## **Experiment Acceptance Review**

Flight: BEXUS 28
Experiment: IRISC

Date: 10. Oct 2019

Telescope holder with STIM300 IMU and Star Tracker Telescope

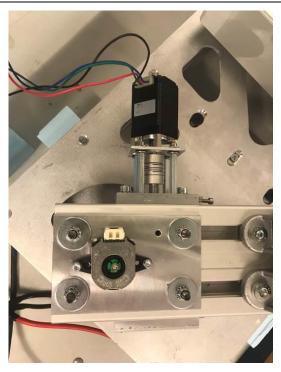
- Mechanics looks really good.
- Well designed and well implemented.
- The selected motors have not been delivered yet. Spare motors have been implemented for now to be able to test. Consider using those motors for flight as far they are qualified by testing.

PCB with RPi. Power distribution circuit

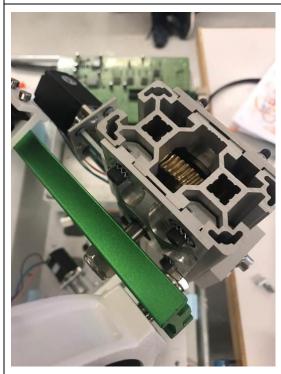
- Communication via Ethernet to between RPi and Ground Station.
- Main PCB not finished. Some components are insufficiently soldered and the connectors are still missing.
